164-194 William Street WOOLLOOMOOLOO NSW 2011

As owner and resident of an apartment in the Horizon building at 184 Forbes Street, Darlinghurst, I wish to lodge an objection to the proposed development at the above address.

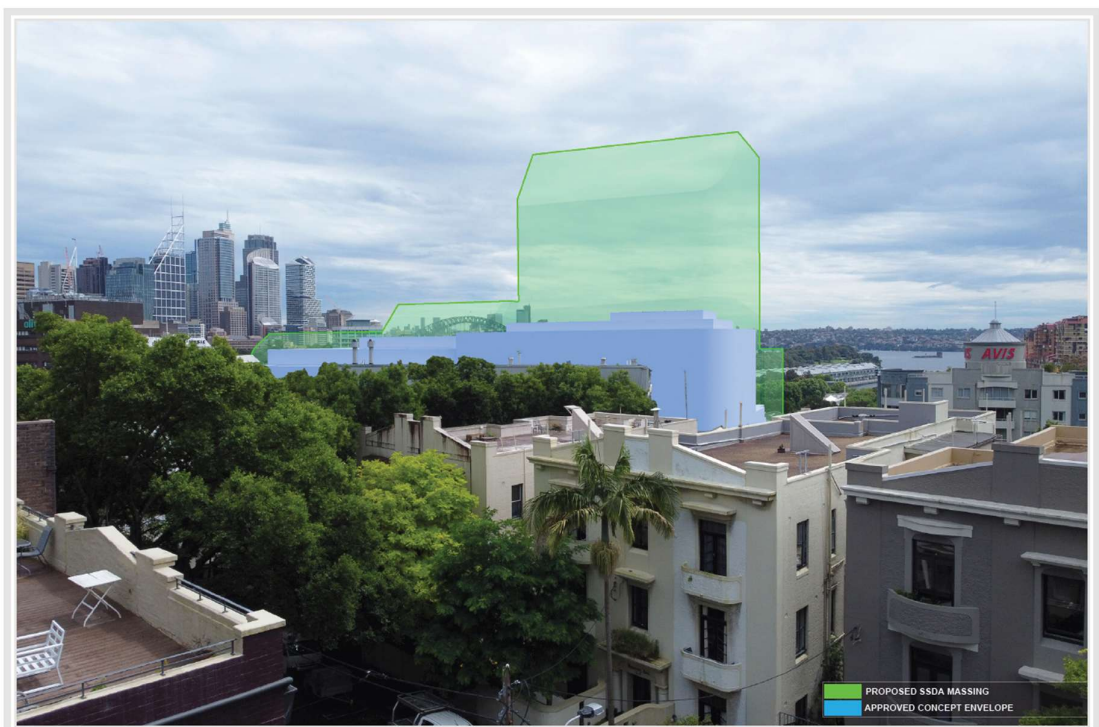
Additional overshadowing to William Street will further exacerbate the already challenging microclimate of the street, as an inhospitable wind tunnel.

If there is a real objective to enhance William Street, as a boulevard, then every effort is needed to provide a place of high pedestrian amenity.

Camera 46 w DJI_0847 c.jpg

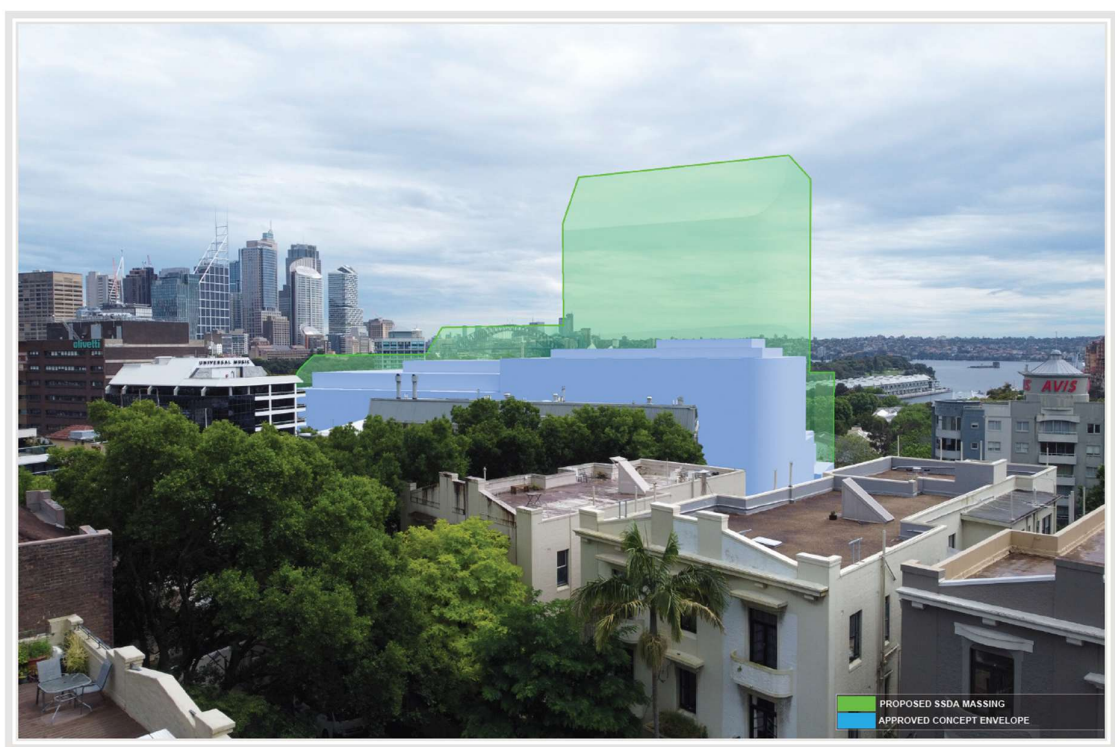
This statement appears to be incorrect as the extracts of the view analysis diagrams included below show the proposed additional height above the approved envelope does block views to the harbour bridge and the opera house (which are considered iconic) at various viewpoints.

I am aware that at the Horizon building there are a number of apartments on levels 3 to 8, which will lose harbour views completely, and other apartments which will have their view significantly impacted. Given the views are of Sydney Harbour, Sydney Skyline, Sydney Harbour Bridge and Sydney Opera House they are considered of significant value.
